MFN 15-040

Response to Request for Additional Information Regarding Review of  
Licensing Topical Report NEDE-33798P, “Application of NSF to GNF  
Fuel Channel Designs”

Non-Proprietary Information – Class I (Public)

**Figure 9a-1 Observations of a No-Settle Condition as a Function of the Year of End-of-Cycle**

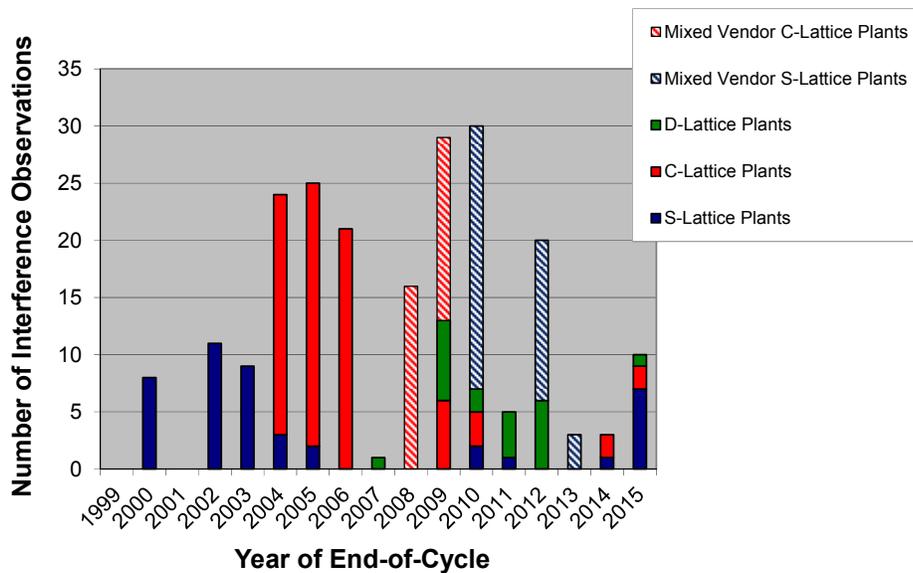
a) Please provide an update on the status of current NSF LUA and expanded NSF LUC programs.

As background first consider the population of observations of interference in Figure 9a-1. The plant population is divided into plant types: S-Lattice, C-Lattice and D-Lattice. The important plant feature that effects channel control-blade interference is the gap distance between channel and control blade. The S-Lattice plants have the smallest gaps while the D-Lattice plants have the largest. Thus, the observations of interference followed the relative susceptibility to interference and first occurred in an S-Lattice plant, then C-Lattice, then D-Lattice. This same information is plotted per plant in Figure 9a-2. The plants listed in Figure 9a-2 provide the population of plants that have experienced channel control-blade interference with Zircaloy-2 and Zircaloy-4 channels.

As part of the current NSF LUC program and the expanded 8% LUC program, NSF channels are being inserted in a significant subset of the plants that have experienced interference (See Figure 9a-3). It is important to note that 8% quantities of NSF channels will be operating in all four S-Lattice plants in the US by the fall of 2015. Since the S-Lattice plants are the most susceptible to channel control-blade interference, any unexpected performance issues with NSF channels will be observed in this leading population and would enable the development of a mitigating response to full reloads inserted in 2016 and after.
